SHEARON HARRIS NUCLEAR POWER PLANT
UNIT NO. 1 - DOCKET NO. 50-400
COMMENTS ON PROOF AND REVIEW TECHNICAL SPECIFICATIONS

Attachment I
Comments on Proof of Review TS

SHNPP Proof and Review Technical Specifications

Figure 2.1-1 Reactor Core Safety Limits Three Loops in Operation

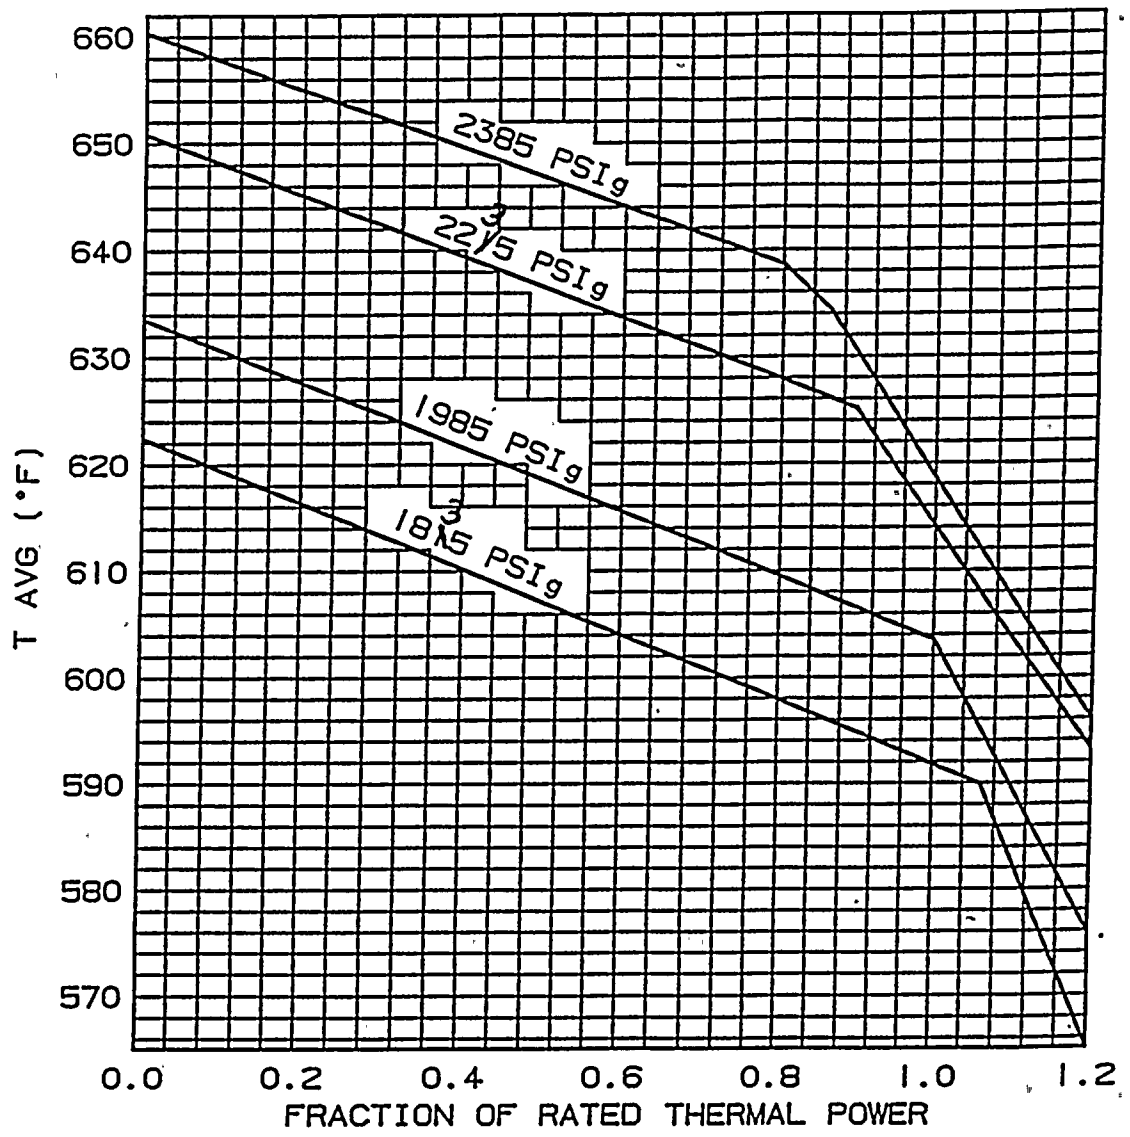
Section Number: FIGURE 2.1-1

REPLACE FIGURE 2.1-1 WITH THE ATTACHED.

A NEW FIGURE IS PROVIDED TO MAKE SEVERAL
TYPOGRAPHICAL AND ADMINISTRATIVE CHANGES TO
IMPROVE THE UTILITY OF THE FIGURE.

Figure 3.2-2 $K(z)$ Local Axial Penalty Function for $F_Q(z)$

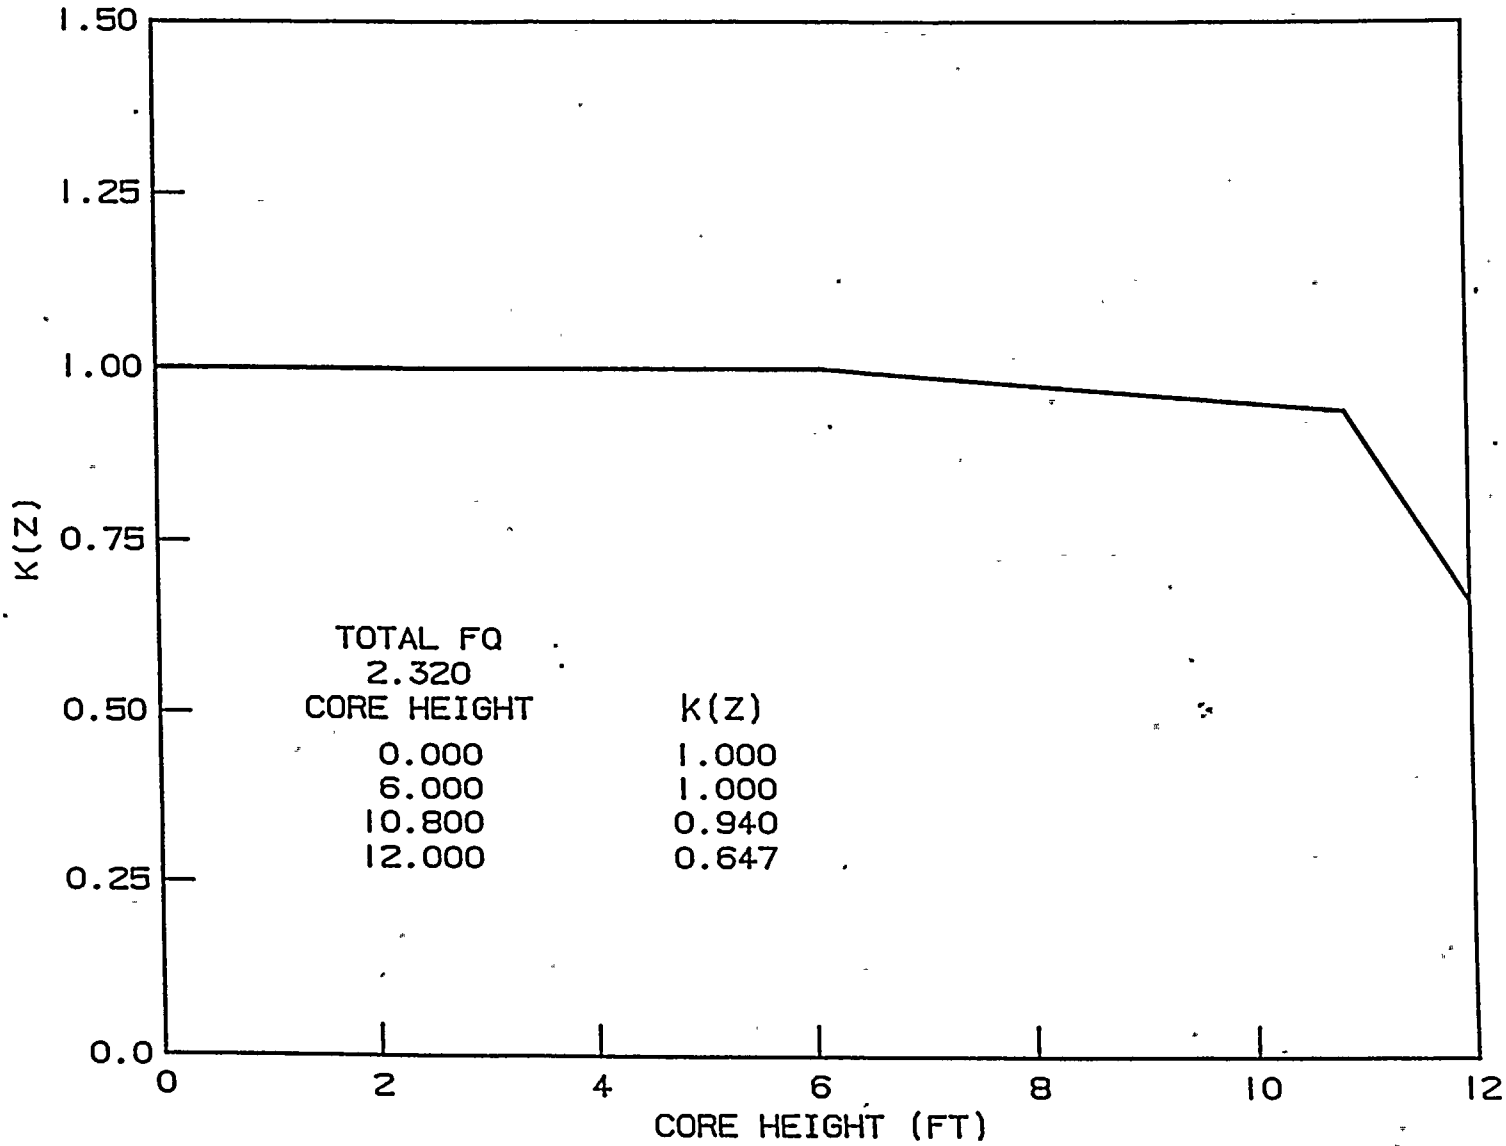
Section Number: FIGURE 3.2-2

NEW FIGURE 3.2-2 PROVIDED.

A NEW CURVE HAS BEEN PROVIDED TO CORRECT DRAFTING INACCURACY AND TYPOGRAPHICAL ERRORS. THE TITLE HAS BEEN REVISED TO CORRECTLY STATE WHAT $K(z)$ IS.

FIGURE 9.2-1

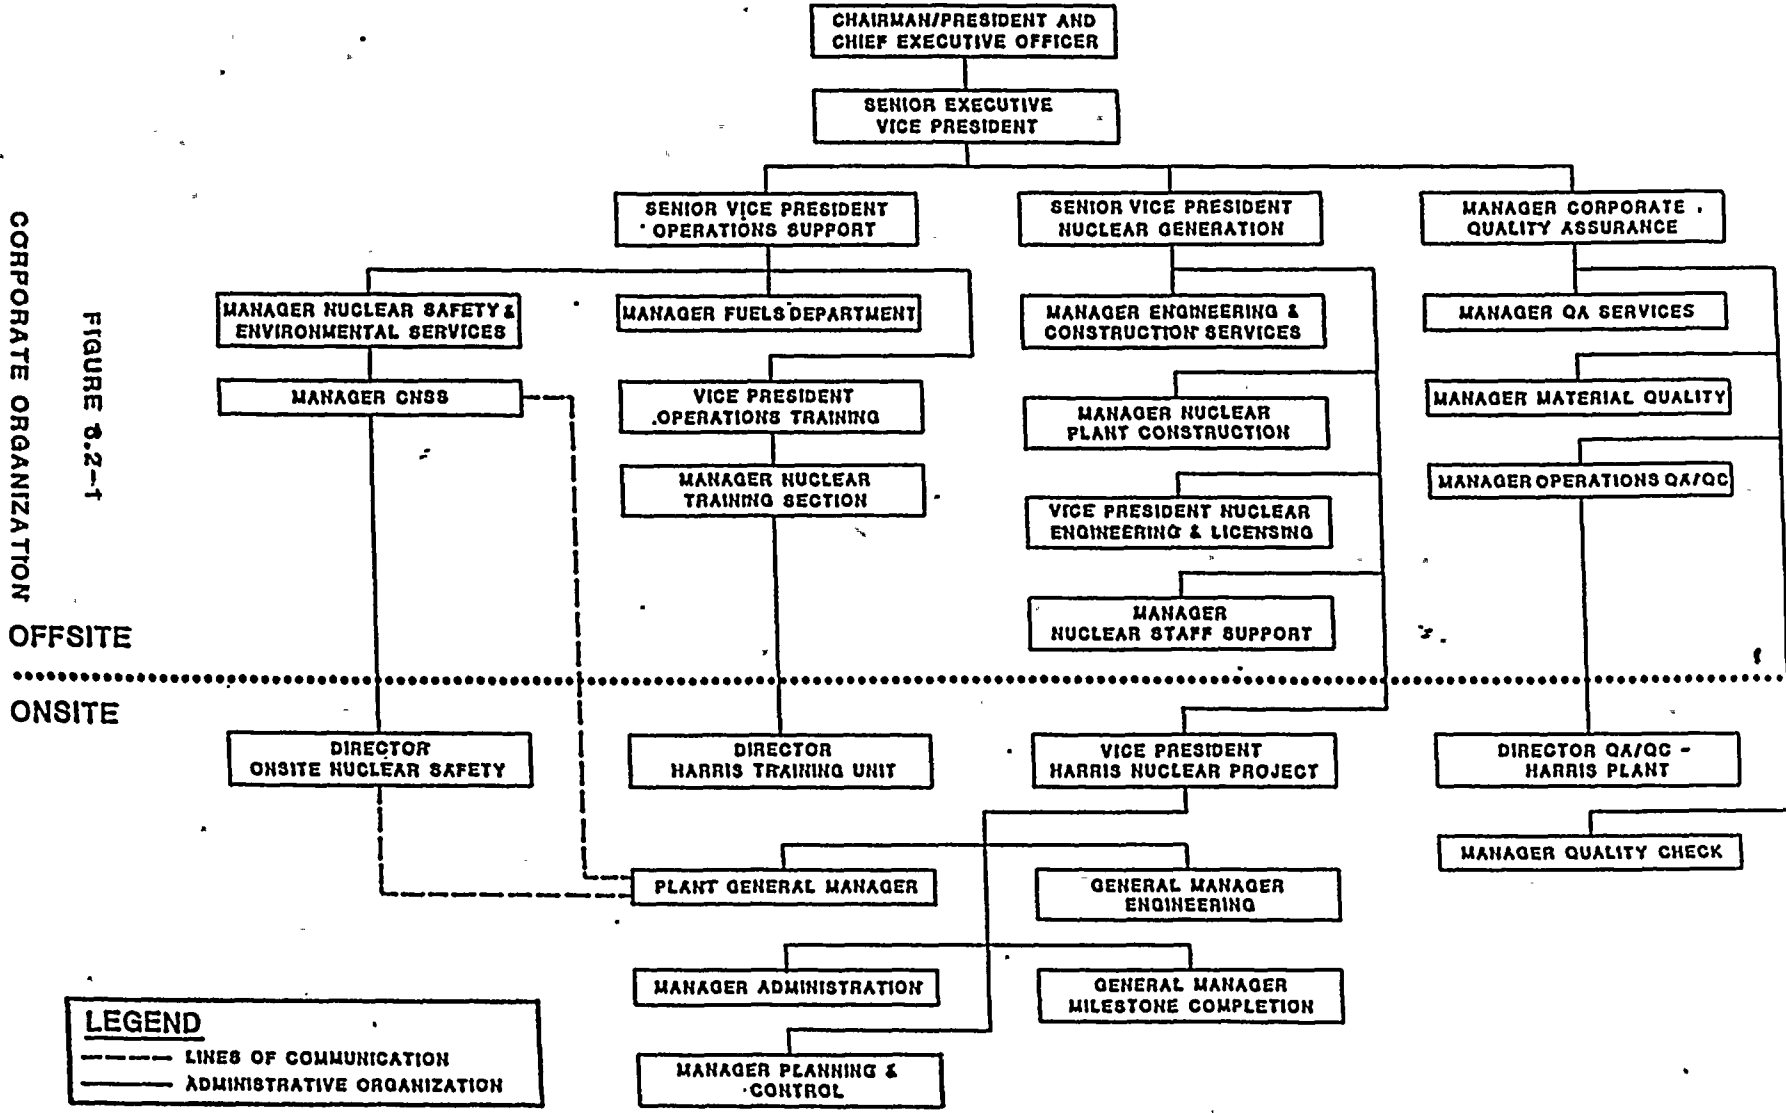
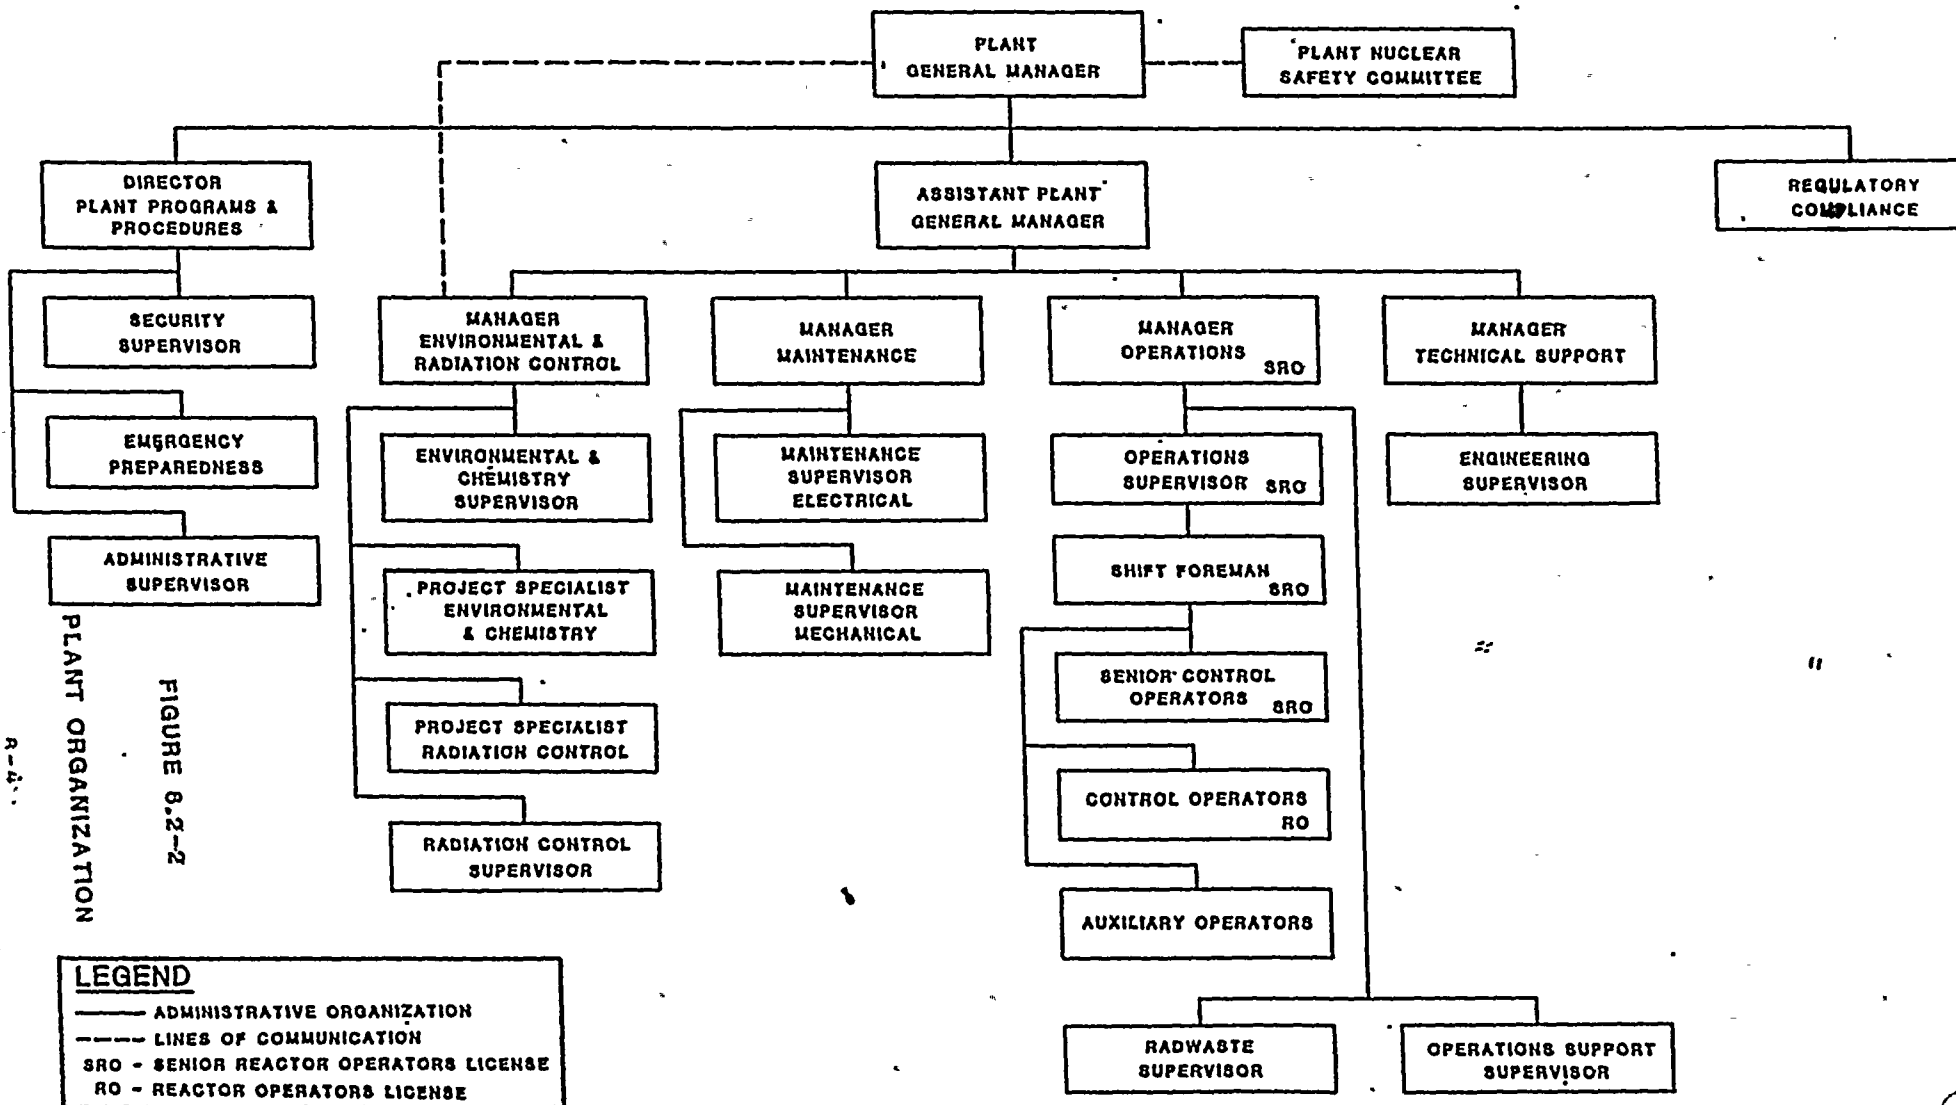
THE NEW ORGANIZATION CHARTS ARE REVISED TO SHOW
THE ORGANIZATIONAL STRUCTURE AND TITLES WHICH CP&L
CURRENTLY EXPECTS TO HAVE IN PLACE AT LICENSE
RECEIPT.
